SILVER LAKE AND IVANHOE RESERVOIRS, HCM #422

Memorandum

Date: May 11, 2020
For: Meghen Quinn, Hargreaves Jones
Subject: Silver Lake Reservoir Complex Master Plan, *Secretary of the Interior's Standards for the Treatment of Historic Properties Analysis*
From: Teresa Grimes, Principal Architectural Historian, and Emily Rinaldi, Associate Architecture Historian

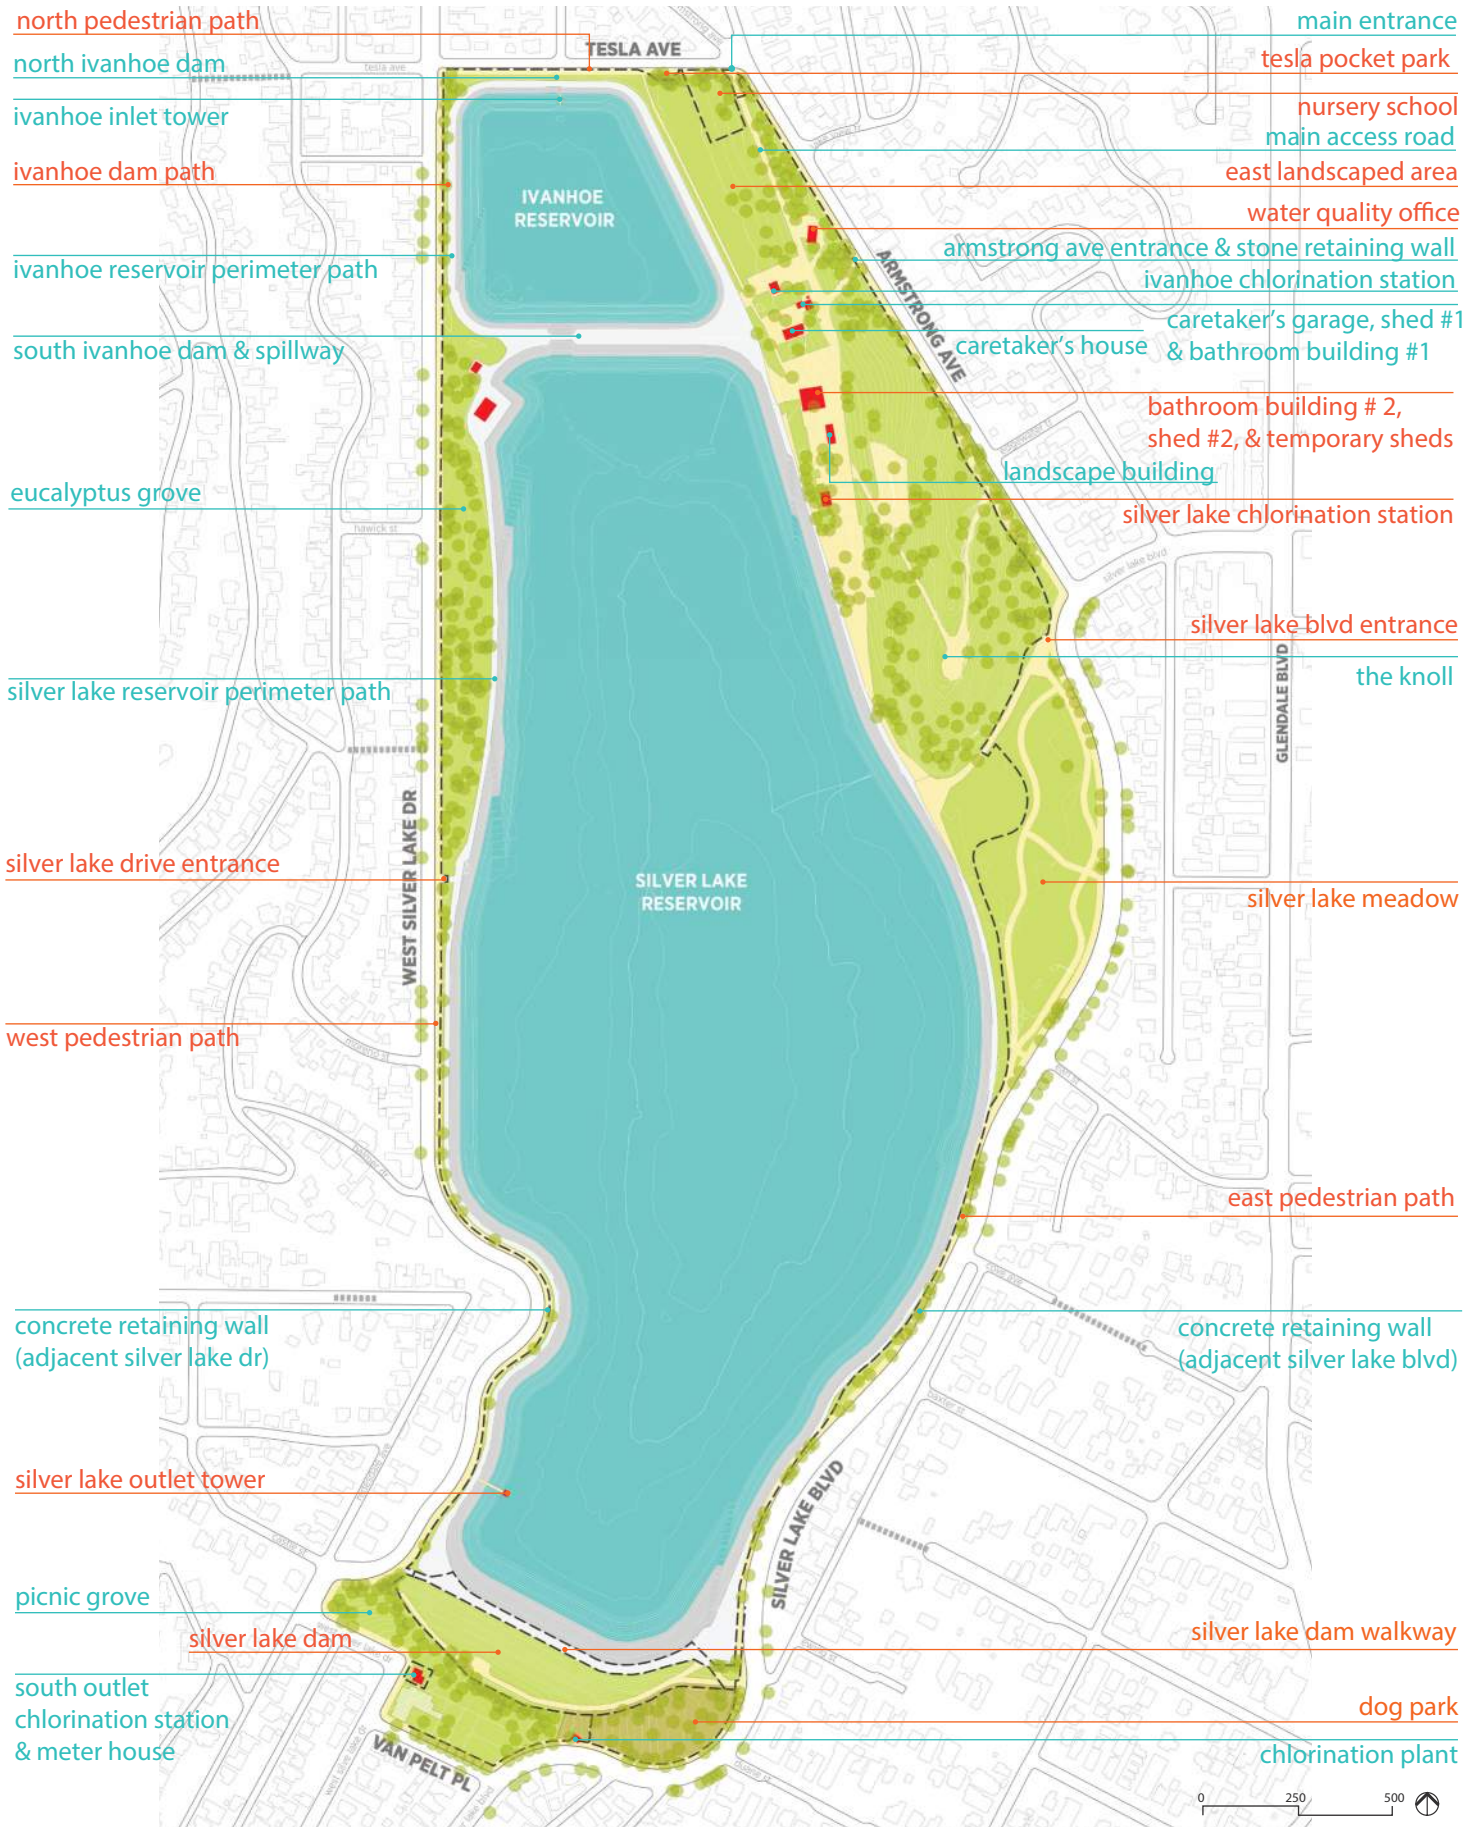
Based on the review of the Proposed Site Plan dated January 23, 2020, the SLRCMP complies with the Standards and Guidelines for Rehabilitating Cultural Landscapes. As the SLRCMP is further developed, GPA encourages the consideration of the following recommendations to ensure the proposed project complies with the Standards:

- The historic concrete retaining walls along Silver Lake Boulevard and Silver Lake Drive should be retained and incorporated into the SLRCMP site plan to the maximum extent feasible.
- A comprehensive tree replacement plan should be developed based on the *Guidelines for Rehabilitating Cultural Landscapes*.
